### 2011 Change Proposals - New Allowances (4 Items)

These are **PROPOSED** Changes only based on driver and director suggestions. Please comment below. These are prposed NEW allowances to the 944 spec rule set.

2011-4.) Lexan rear Qtr windows

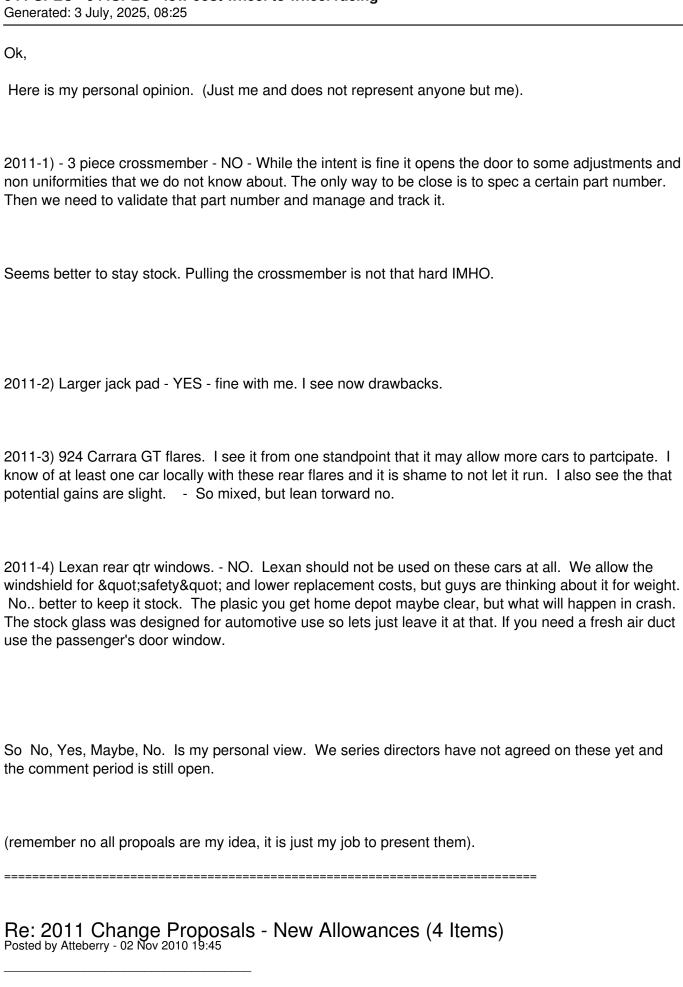
**Proposal:** Allow rear replacement of glass qtr windows with lexan and to allow air ducting to be installed in these lexan windows. No changes to rear hatch.

Justification: Makes it a nice clean way to provide fresh air ducting.
